Subject: Conditional Approval of Reduce Hydrologic Monitoring Sites, PacifiCorp, Deer Creek Mine, C/015/0018, Task #5770

Technical Analysis and Findings

PID: C0150018
TaskID: 5770
Mine Name: DEER CREEK MINE
Title: REDUCE HYDROLOGIC MONITORING SITES

DEER CREEK MINE WATER MONITORING ANALYSIS

Figure 12. Grants Spring discharge vs. PHDI Region 4 Pre- and Post-mining trends

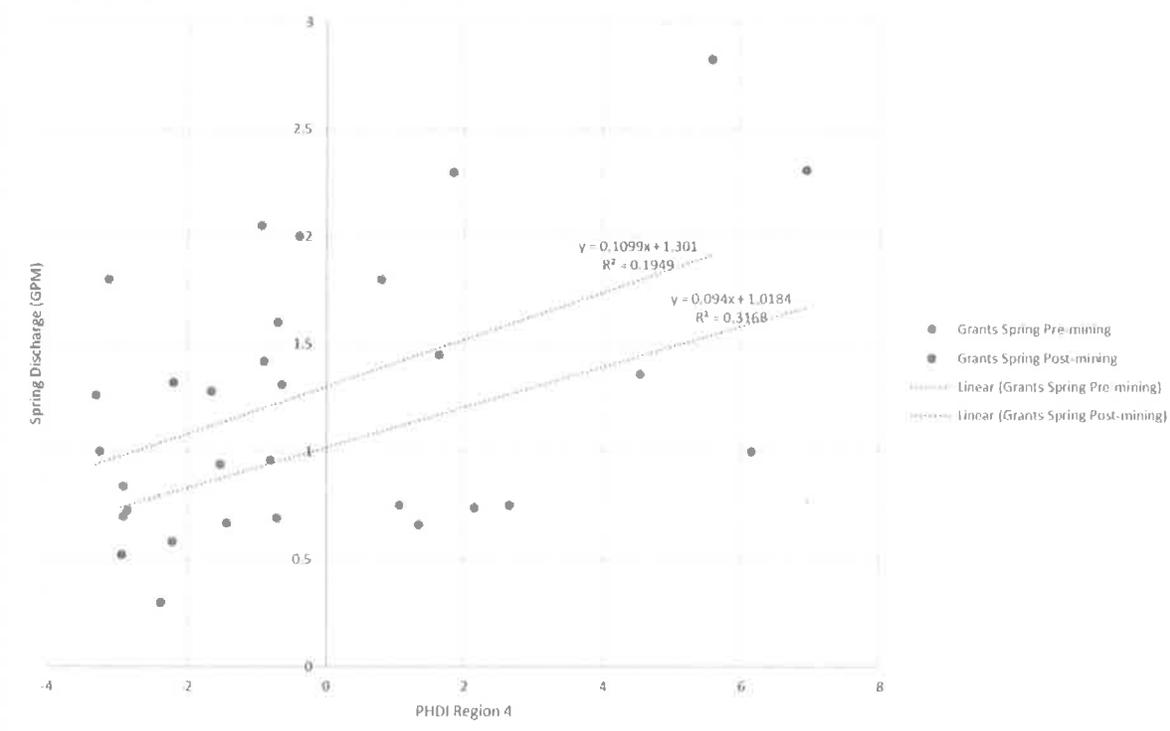
This spring is near the top of the drainage divide of East Mountain. The closest mining occurred more than 1500 feet to the north in late 2005. The spring discharge ranges from 0.5 to about 3 GPM. Flows appear to be consistent through time. The graph of discharge vs. PHDI Region 4 shows the pre- and post-mining trends are nearly the same (Figure 12). Spring discharge rates appear to be unaffected by mining activities. This spring may be removed from the hydrologic monitoring plan.

Figure 13. RR-15 spring discharge vs. PHDI Region 4 pre- and post-mining trends.

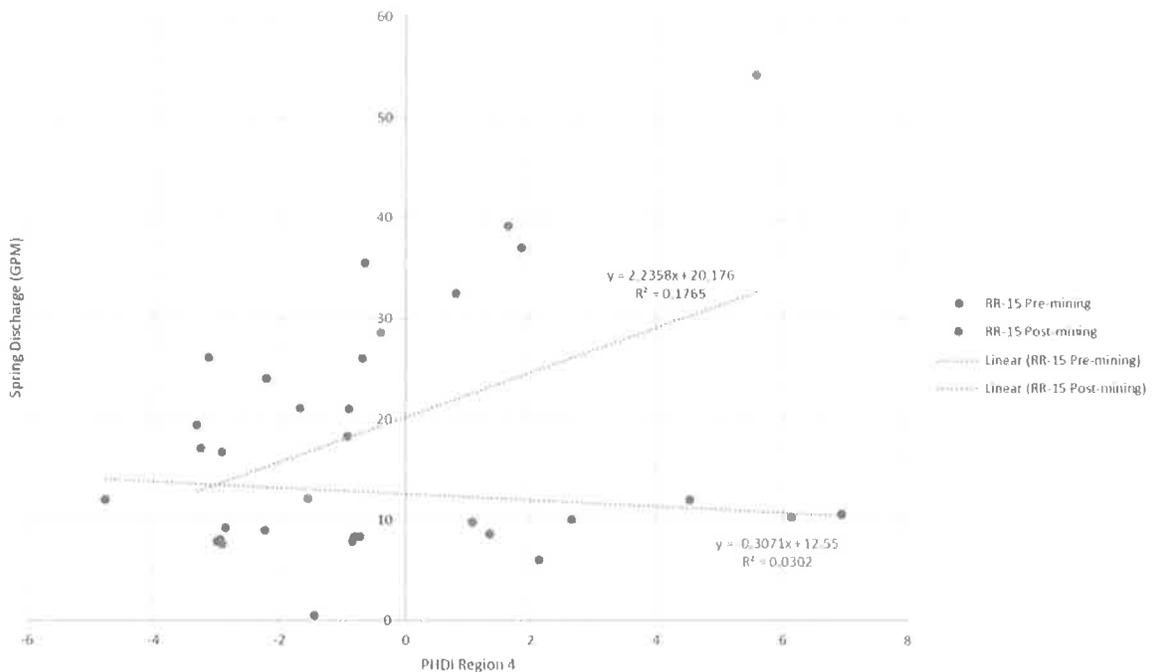
This spring is adjacent to the east end of the second panel mined in the Mill Fork Lease. The nearest second mining occurred 55 feet away from the spring in March 2006. The pre-mining trend appears to not correlate with the PHDI. Post-mining spring flows correlate positively with the PHDI. The spring discharge rates have stayed consistent through time ranging from about 10 to 55 GPM. It appears precipitation is a strong driver of the flow rates at the spring. Spring discharge rates appear to be unaffected by mining activities. This spring may be removed from the hydrologic monitoring plan.

Figure 14. RR-23A spring discharge vs. PHDI Region 4 pre- and post-mining trends.

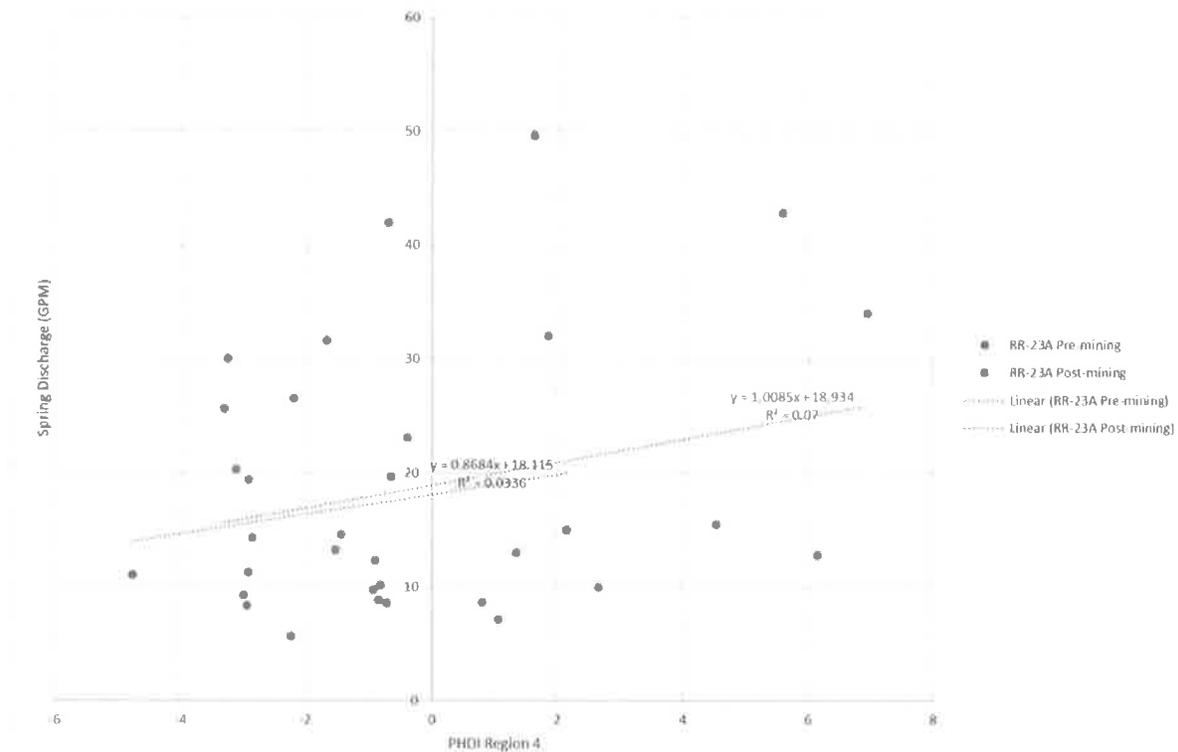
This spring is located near the southeast corner of the Mill Fork lease and was one of the earliest sites to have first mining within the lease pass nearby. Pre- and post-mining trends of spring discharge vs. PHDI are similar (Figure 14) and the spring appears to consistently discharge at the same rate during the time it has been monitored. Spring flow rates range from 10 to 50 GPM. Spring discharge rates appear to be unaffected by mining activities. This spring may be removed from the hydrologic monitoring plan.

Figure 15. EM Pond spring discharge vs. PHDI Region 4 pre- and post-mining trends.

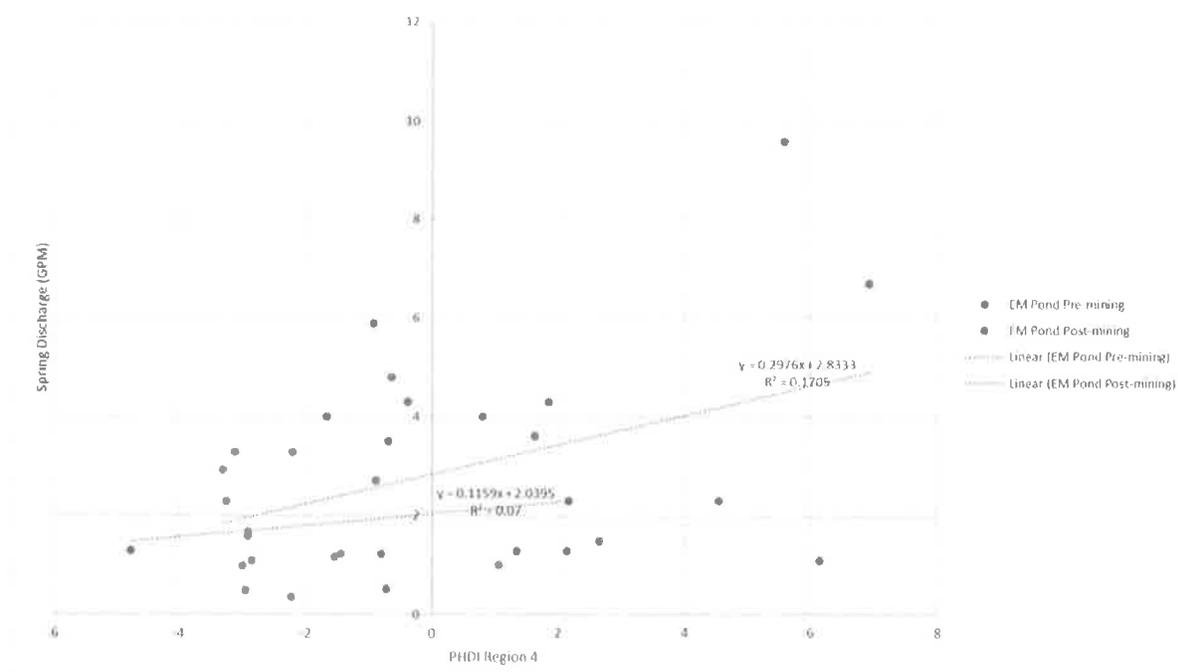
This spring is located south of the Mill Fork lease workings. The closest maximum subsidence from this site is 1,500 feet to the north. Flows have consistently been recorded between about 1 to 6 GPM for the duration of monitoring. The pre- and post-mining trend of discharge vs. PHDI Region 4 appear to be similar. Spring discharge rates appear to be unaffected by mining activities. This spring may be removed from the hydrologic monitoring plan.

Figure 16. Sheba Spring discharge vs. PHDI Region 4 pre- and post-mining trends.

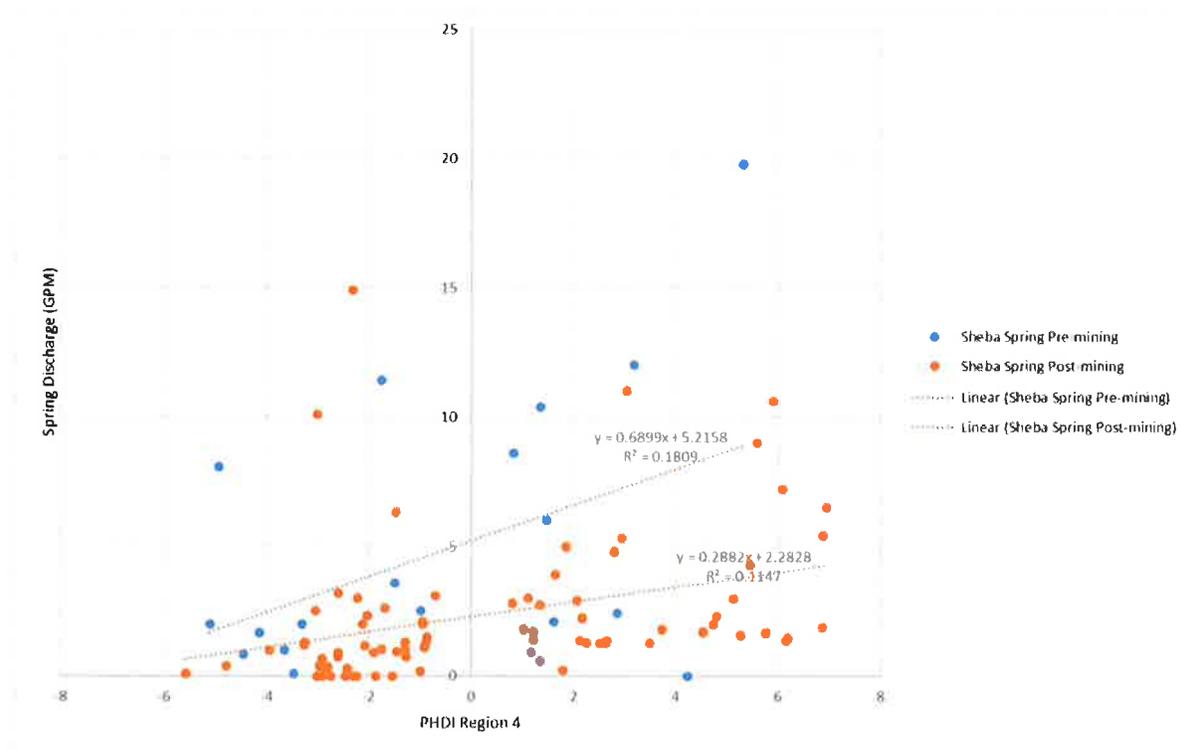
This spring is located above the Deer Creek workings on the downthrown Roan’s Canyon fault graben. The spring was not undermined during mining activities that took place over two and half decades ago. Discharge rates trend well with precipitation and PHDI for the duration of monitoring. The trends of spring discharge vs. PHDI are both positive and appears to have only lessened slightly post-mining. Flows have been recorded to range from 0 to 25 GPM. This spring is developed with a spring box and trough for livestock and continues to be a watering source for the grazers. Spring discharge rates appear to be unaffected by mining activities. This spring may be removed from the hydrologic monitoring plan.

Figure 17. Rilda canyon piezometer measured depth to water level vs. date sampled.

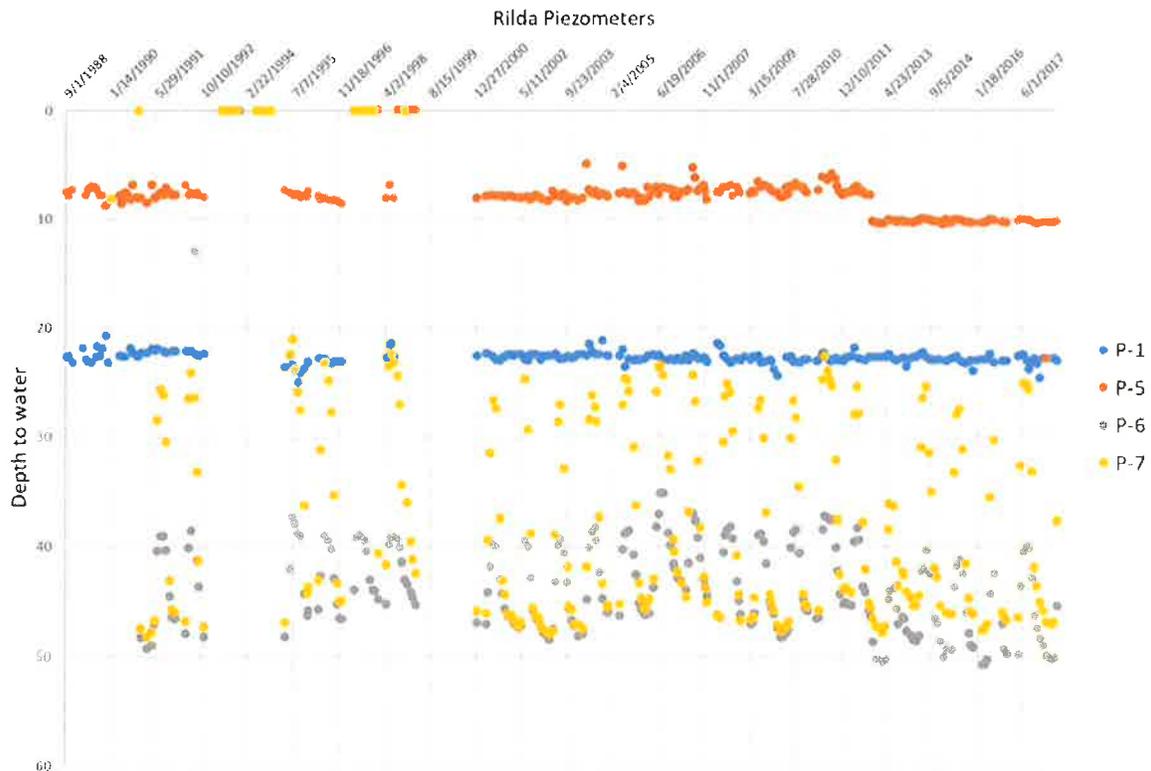
The amendment proposes to remove monitoring requirements for the four piezometers in Rilda Canyon. These are shallow piezometers within the alluvial deposits along Rilda canyon creek. The depth to water level data is plotted in Figure 17. The water level data appears stable through time for all of the piezometers. Piezometer P-5 dropped then leveled out at a very consistent value. The groundwater level in this area probably dropped below the well casing and sampled values are the depth to the wet material at the bottom of the casing. NEWUSSD worked on their collection boxes upgradient of this well around this same time which may have caused this drop in groundwater level. Wells P-6 and P-7 show seasonal fluctuations in water level, but overall have been consistent through time. Well P-1 has been the same consistent level though time. It does not appear mining has impacted water levels in these wells. These wells may be removed from the hydrologic monitoring program.

Figure 18. Well Em-47 depth vs. date monitored. Well installed in early 1980's and monitored through to the present.

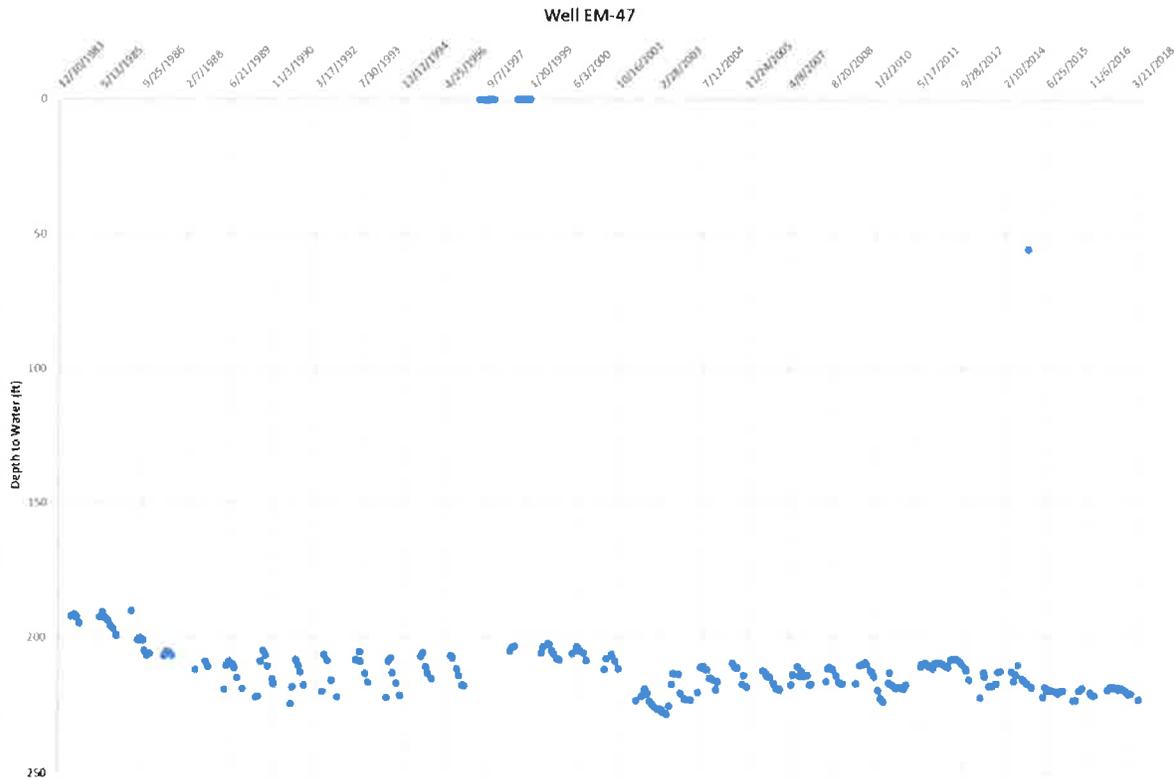
This well is screened in the lower Blackhawk below the Hiawatha coal seam. The groundwater within the sandstone lens in this zone is not under tremendous confined pressure because the unit outcrops not far downdip in the bottom of Rilda Canyon. The depth to water level graph (Figure 18) shows the well appears to respond to climatic and even seasonal variations. The well water level has not dropped much for the duration of monitoring. It does not appear mining has impacted the water level in this well. Well EM-47 may be removed from the hydrologic monitoring program.

Figure 19. Indian creek baseline flows (GPM) vs. PHDI Region 4. Flow rates are log-transformed to normalize the dataset.

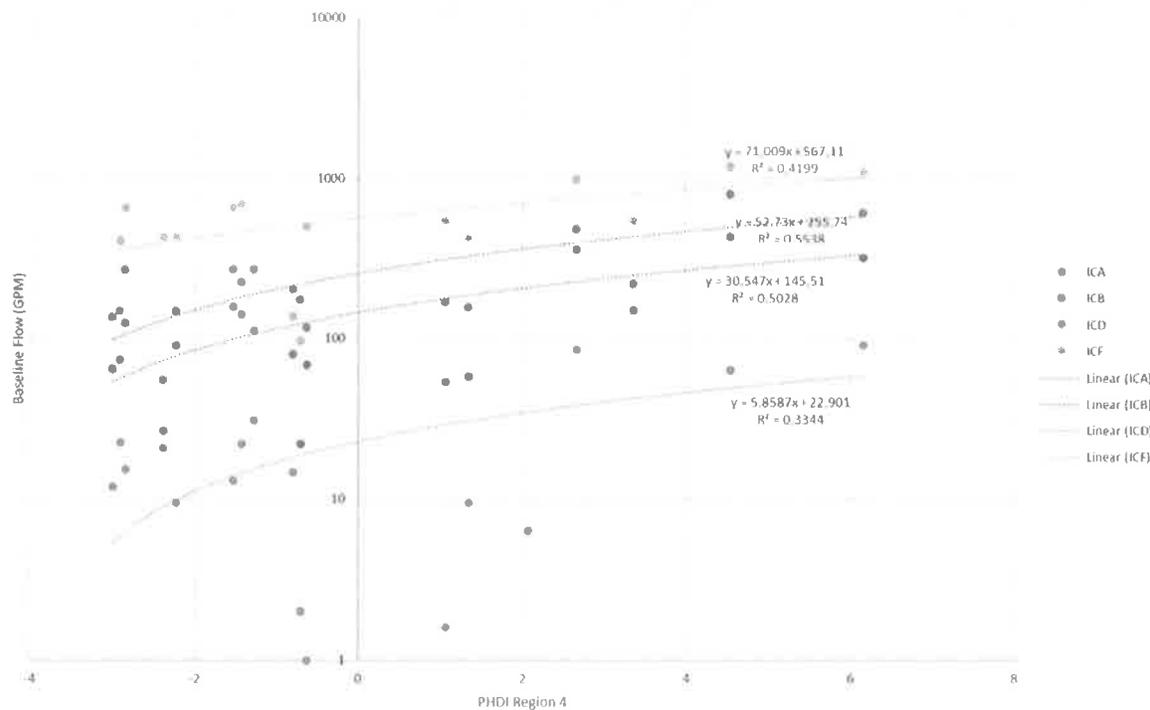
These sites are located along Indian Creek running through Upper Joe's valley, west of the Mill Fork Lease. Monitoring began at these sites in 2001. They are monitored only during baseflow conditions in October each year. Indian creek is west of the Joes Valley Fault, over a 1/2 mile west of the limit of the coal reserve. No mining took place underneath or directly adjacent to the stream so subsidence has not impacted channel along its length. The stream is used by grazers as a water source for irrigation and livestock. Graphing the PHDI vs. baseline flow shows all the sites have similar trend lines with positive correlations, or the wetter the climate the more flow in the stream and vice versa for drought years. It appears mining has not influence the flows in Indian Creek. These sites may be removed from the hydrologic monitoring program.

Figure 20. Recorded stream flows (GPM) along Meetinghouse creek vs. PHDI Region 4. Flow rates are log-transformed to normalize the dataset.

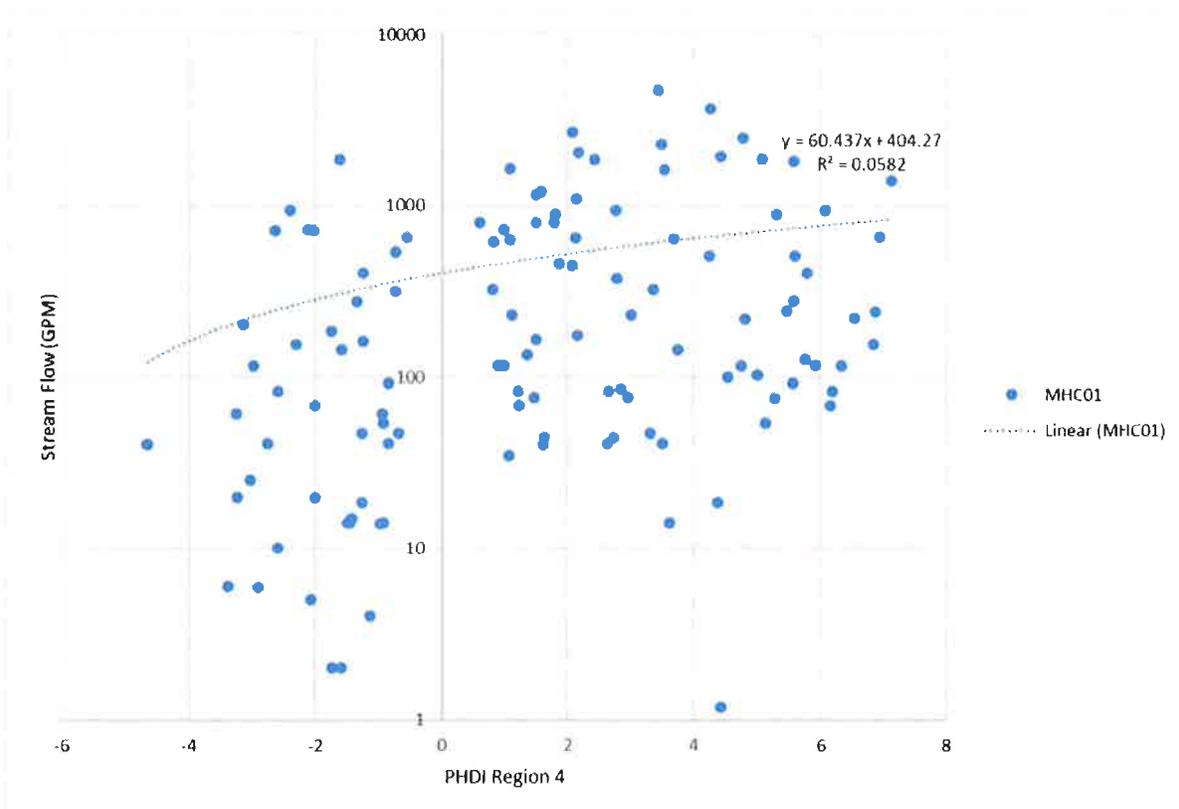
Monitoring of this surface water site began in 1984. It is monitored for flow monthly and quarterly for quality when it is flowing. A graph of surface flow rates is provided in the amendment. The stream appears to be intermittent/ephemeral with runoff typically occurring during snowmelt and summer monsoon events. The rest of the time the stream site has no flow. The site was not undermined and mining within the contributing watershed occurred in the late 1980's and early 1990's. The stream has flowed more consistently into the summer months when the PHDI ranges from 2 to 6 during climatic wet cycles. Recorded flows trend positively vs. the PHDI Region 4 (Figure 20). It appears mining has not affected quantity or quality for this site for the duration of monitoring. This site may be removed from the hydrologic monitoring program.

Figure 21. Recorded stream flows (GPM) along Mill Fork creek vs. PHDI Region 4. Flow rates are log-transformed to normalize the dataset.

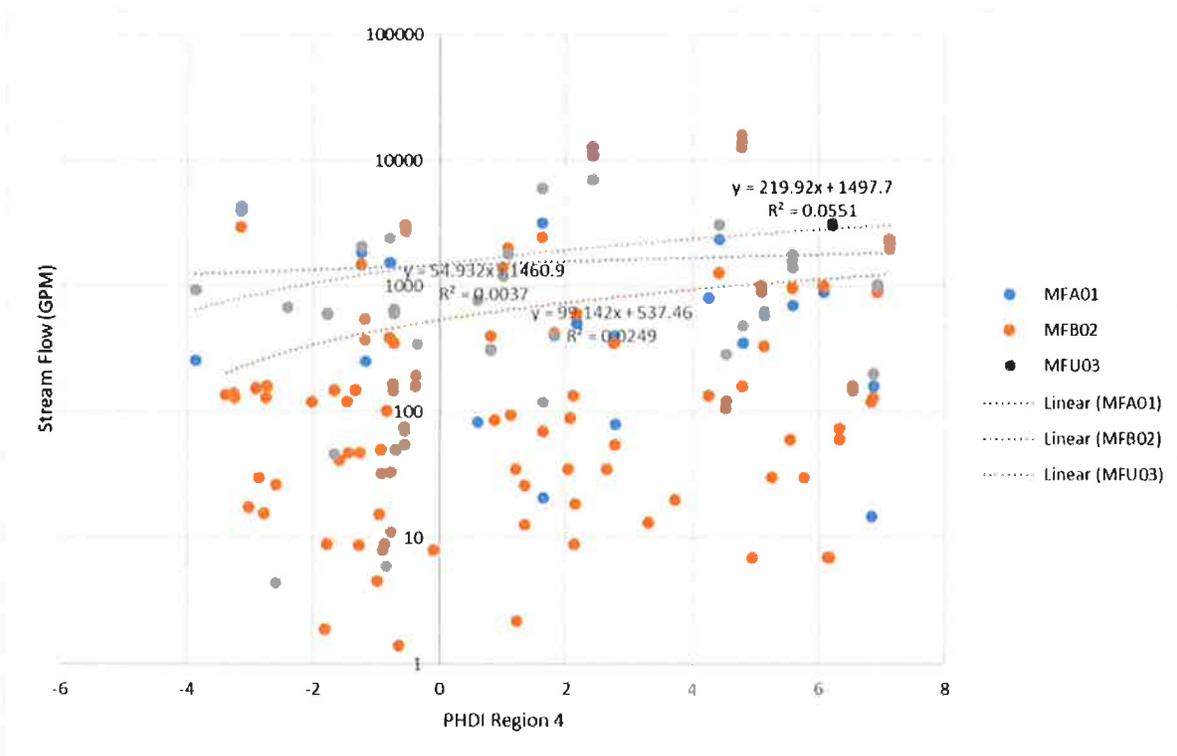
Monitoring along Mill Fork canyon creek at MFA01 and MFB02 began in 1997 and MFU03 began in 2002. The sites are monitored for flow monthly and quarterly for quality when it is flowing. For the duration of monitoring the creek has flowed intermittently and ephemerally with no flow recorded at the monitoring points the vast majority of the time. Recorded flows plotted against the PHDI Region 4 shows there is a positive correlation between climate and flow rates (Figure 21). Site MFB02 is the lowest site along the creek and has quite a few more recorded flows than the other two sites. It likely receives groundwater discharge from the lower Blackhawk or Star Point formation outcrop in the bottom of the canyon bottom in addition to surface runoff. Mill Fork Creek has three point to point surface water rights running along its length. From top to bottom they are 93-198, 93-197, and 93-196 which terminates near MFA01. The upper catchment of the creek was second mined in both the Blind canyon and Hiawatha seams. It appears mining has not affected quantity or quality across these three sites for the duration of monitoring. These site may be removed from the hydrologic monitoring program.
